Public Comment for May 2, 2017 Submitted by Margaret Tweet, citizen Clark County, WA

If more tax \$ are spent on the CRC I-5 replacement bridge, consider the following

Exhibit 4-5. USACE Columbia River at Vancouver Water Level Data (1987-2006)

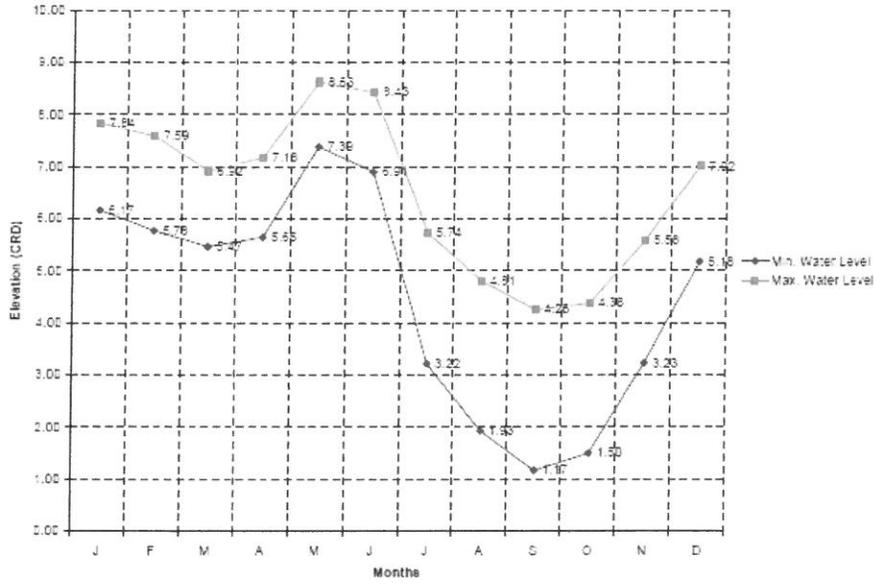
DEIS, CRC Navigation Technical Report exhibit 4-5 is an example of CRC incomplete data.

*Minimum and Maximum water levels are shown only for the years 1987-2006

*The data is not actual river levels, but is averages and should be labeled accordingly.

The highest water level shown on CRC Ex. 4-5 is under **9 ft.**

The highest actual recent water level shown by the Vancouver gage is **27.2 ft in 1996**
